Peppertree Quarry Modification 5

ENVIRONMENTAL ASSESSMENT PRELIMINARY RESPONSE TO SUBMISSIONS

Prepared for Boral Quarries | February 2019

Figure 1

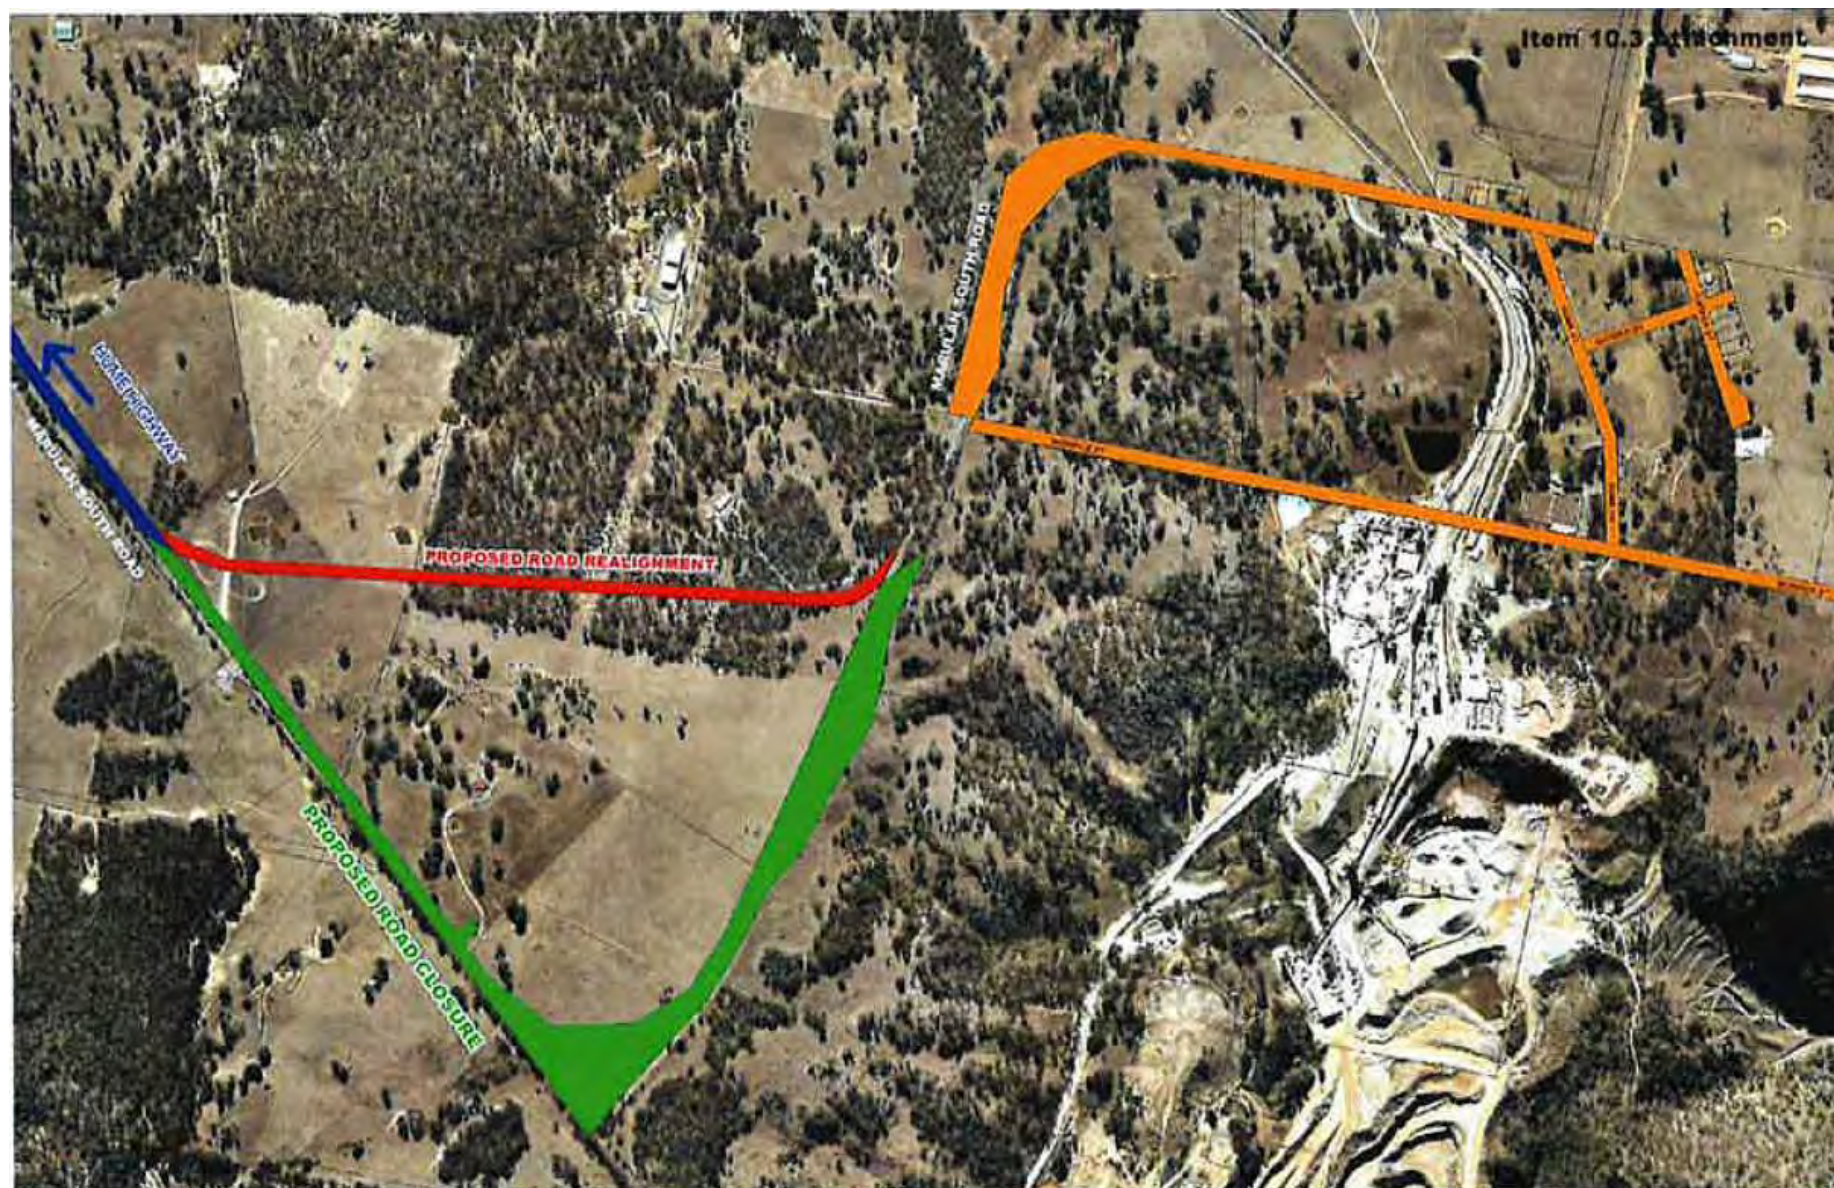
Council is currently negotiating with Boral in relation to the closure and purchase of Council roads within the site (refer Attached, Figure 1).

Figure 2

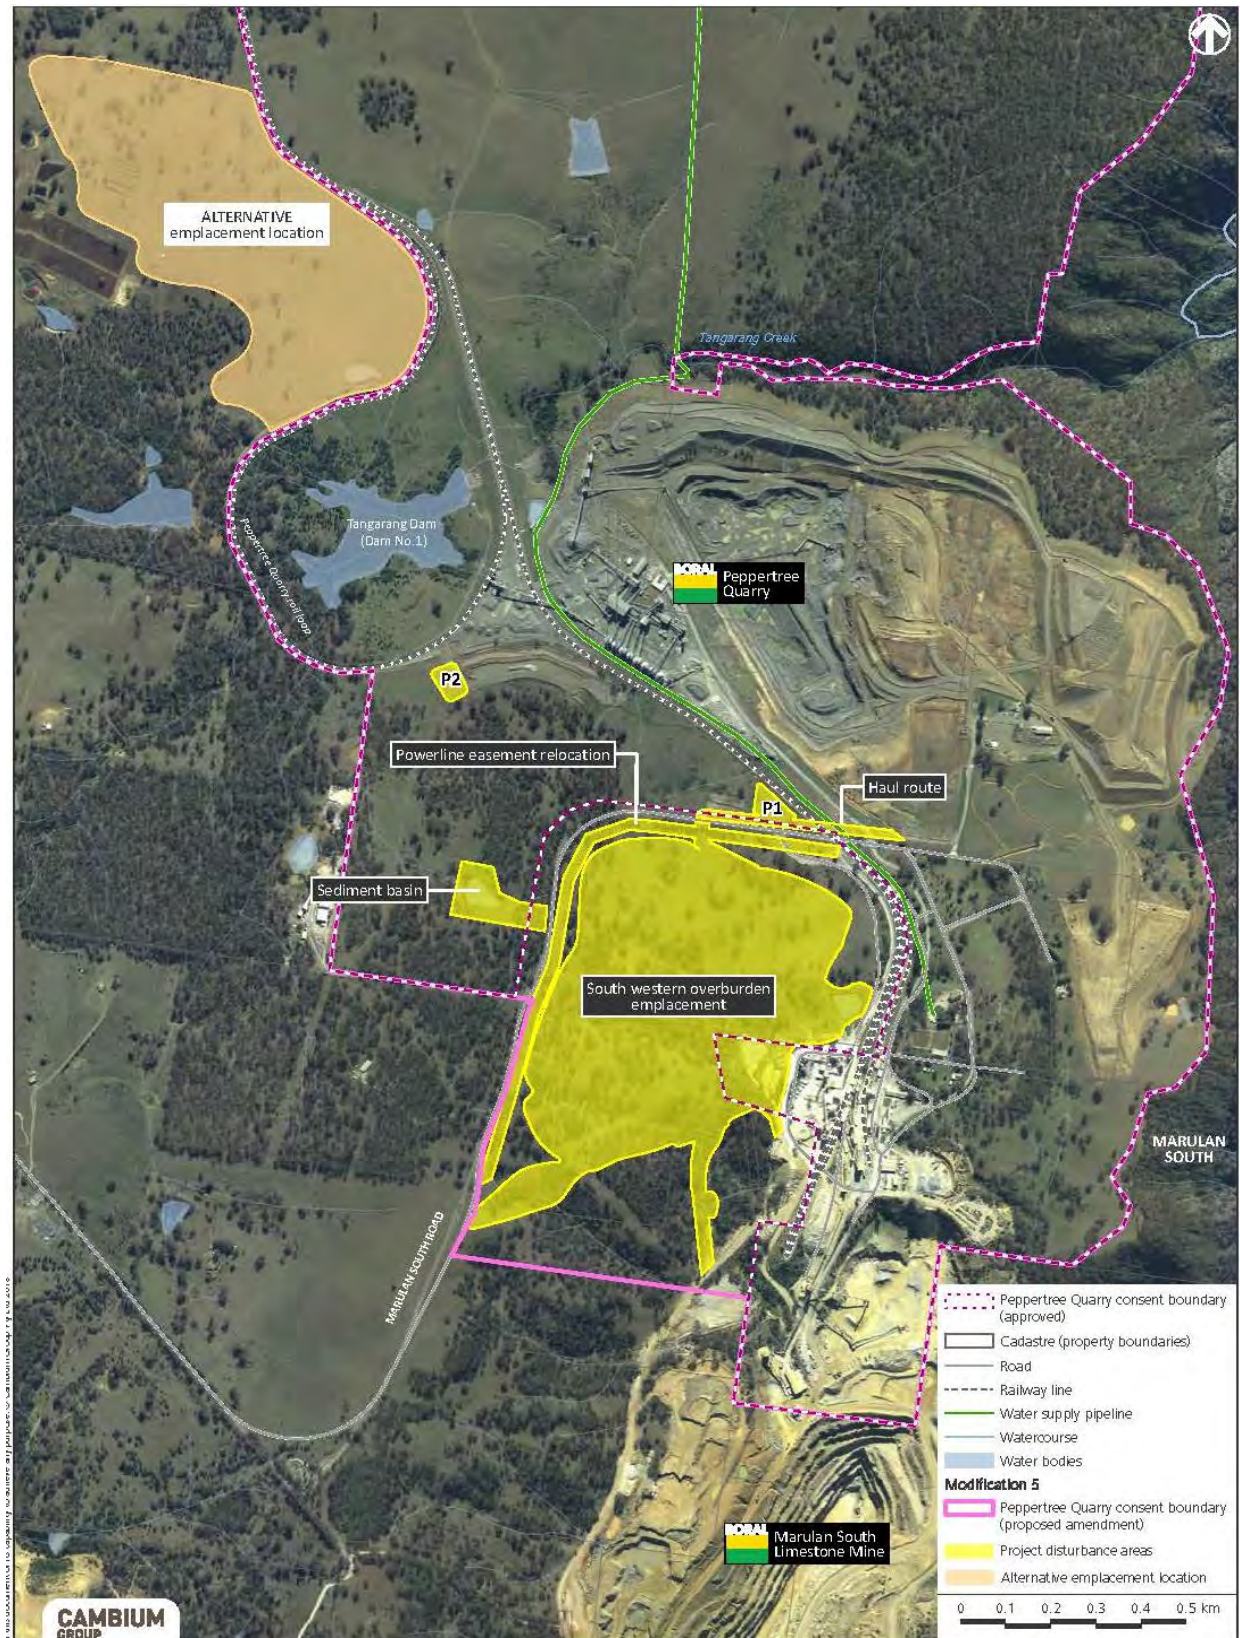
If the road closure permits are not finalised before this road is operational the haul road will conflict with a public road (Refer Attached, Figure 2).

Figure 7
The Project

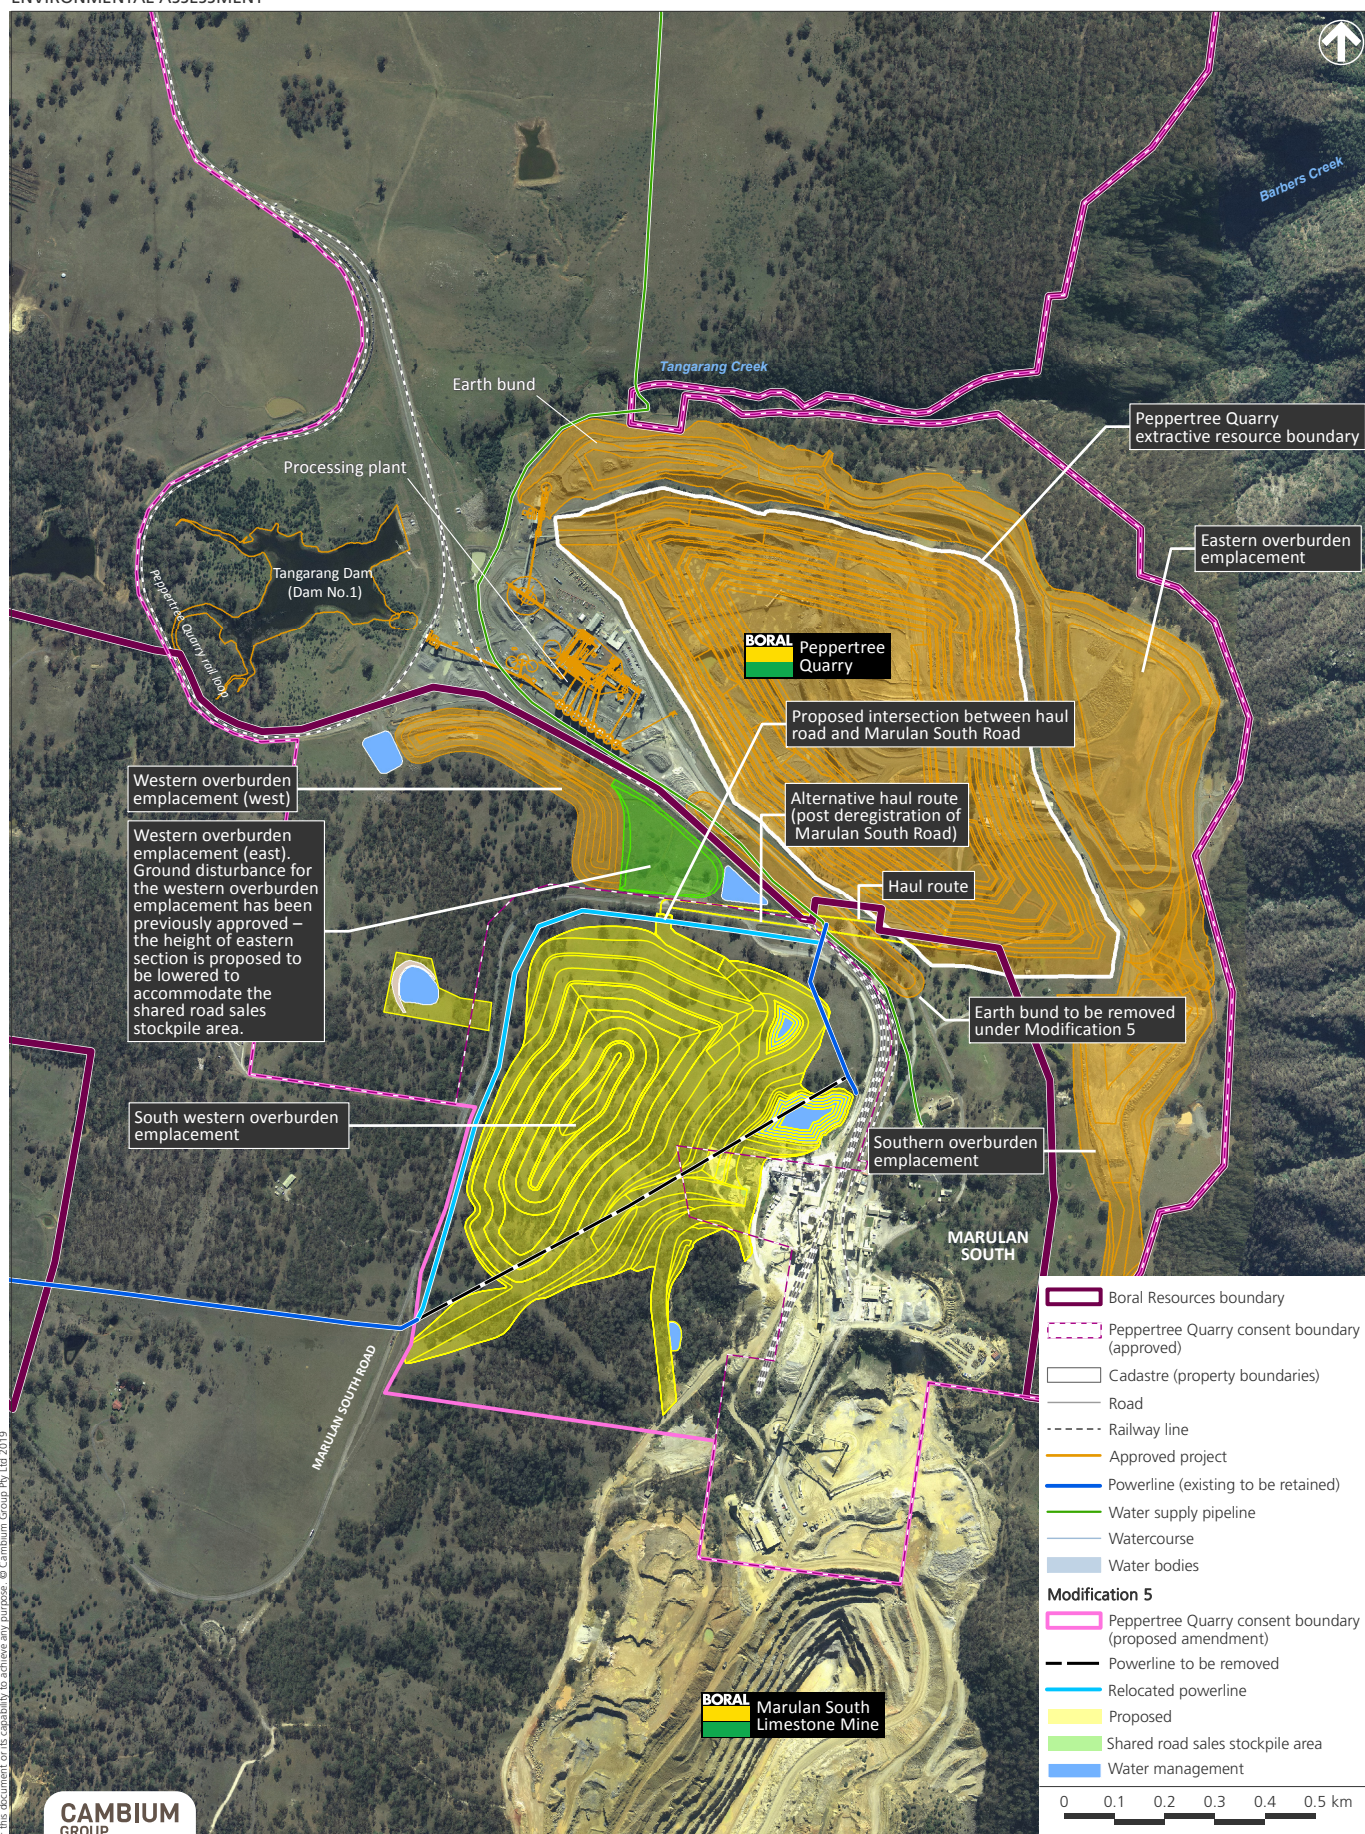
Provide a map which clearly delineates the positioning of the proposed intersection scenarios.

A plan has been prepared by Cambium showing the location of the alternate intersection location (Appendix E).
